Access Compliance Report Public Rights-of-Way (Curb Ramps)

Intersection ID: 10608 Main Street: N_DAVIDSON_ST Cross Street: JORDAN_PL Location: NE
ADA ID: 8F57CF8C877C Ramp Type: Combination2 Initial Pass/Fail: Fail Overall Compliance: No Severity Score: 10

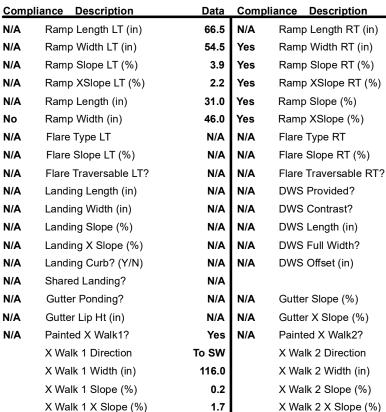
LT RP < 5%

N/
PROW/ADA:
Not Found, R304.5.1

Remove & Replace Entire Ramp.
